U.S. Department of Energy

Subject: Response to the Request for Additional Information on "Field Procedures for the Radiological Excavation Control and Radiological Verification of the Moab Project Site"

In response to your letter of August 11, 2005, requesting additional information on the proposed procedures for use at the Moab Project site, the DOE offers the following:

Decision Tree for Interior and Exterior

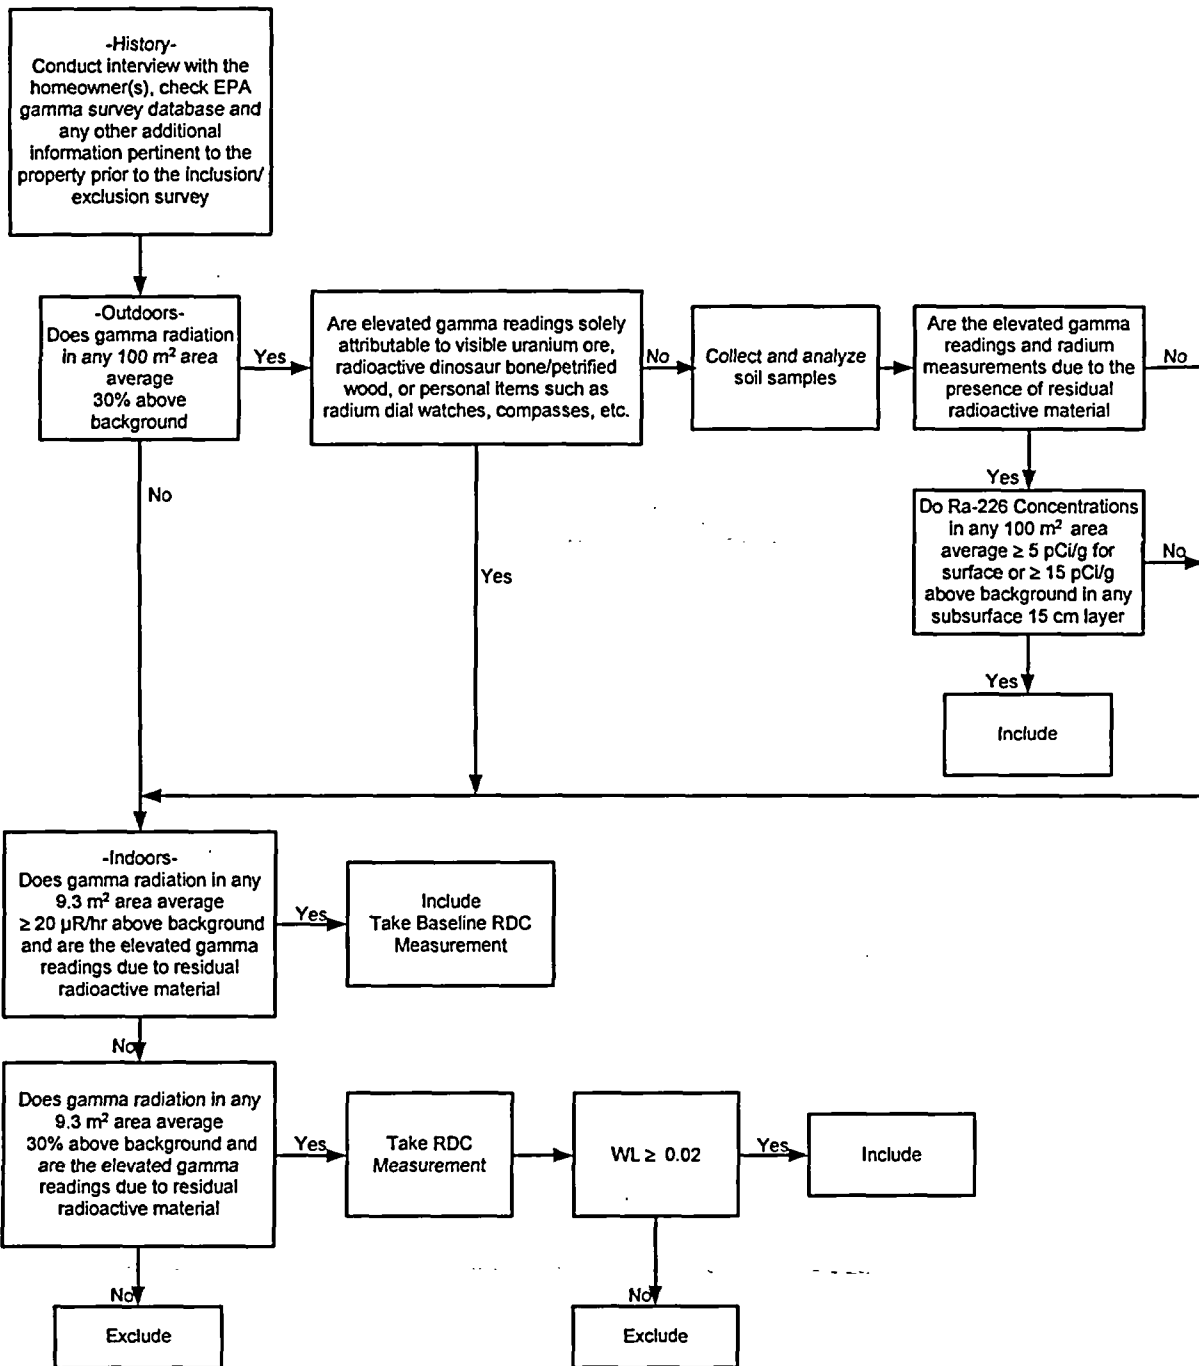
Attachment 1, Page 4, Section 2.4

The inclusion/exclusion survey decision tree (enclosed) and associated text in Attachment 1 will be revised to correct the inconsistency for initiating soil sampling for inclusion purposes when the gamma exposure rate is 30-percent above background (1.3 times background) averaged over a 100 square meter area. This change should address concerns of buried tailings deposits that might have been missed using the 25 μ R/h above background criterion.
